COMPLIANCE SUBMISSION

APR'22 PH-DG SCALE: 1:200 **ELEVATIONS** 1 Grantham Street, Dublin 8, D08 A49Y, Ireland.
Tel: 01-4788700 Fax: 01-4788711 E-Mail: arch@mcorm.com |8025.2| CP203

03- SOUTH ELEVATION 1. Rural Blend Red Brick

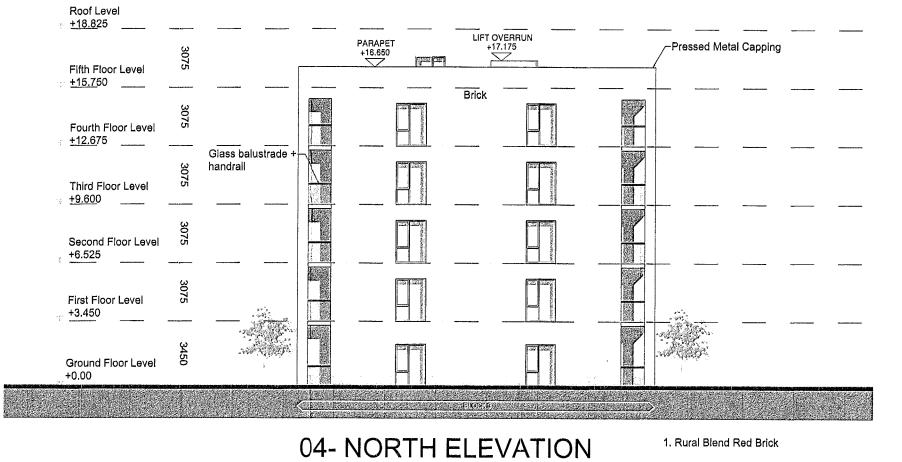
REVISIONS DATE DESCRIPTION 10.02.23 Clarification of Brick Type Finishes Α

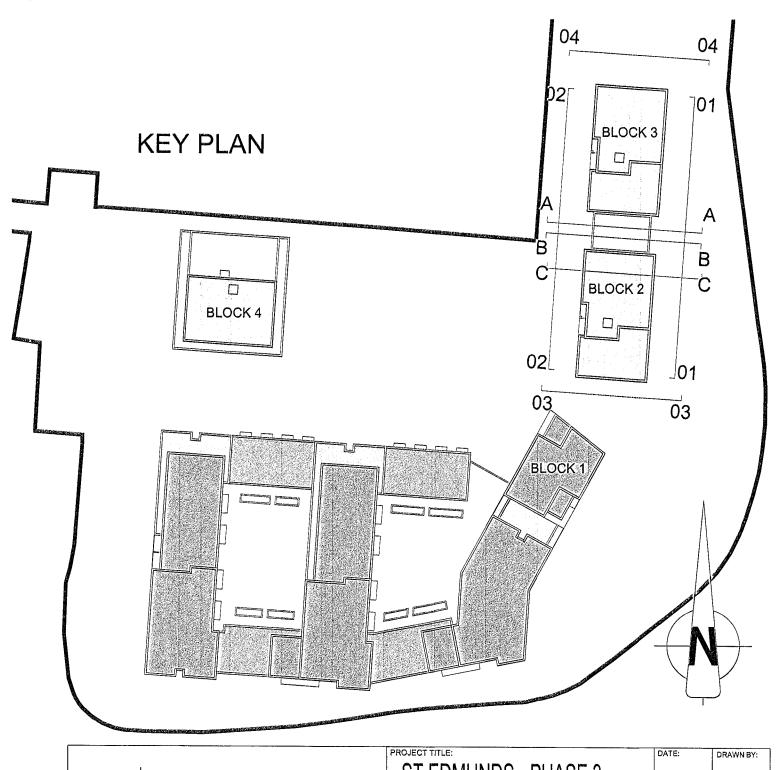
Render removed from material
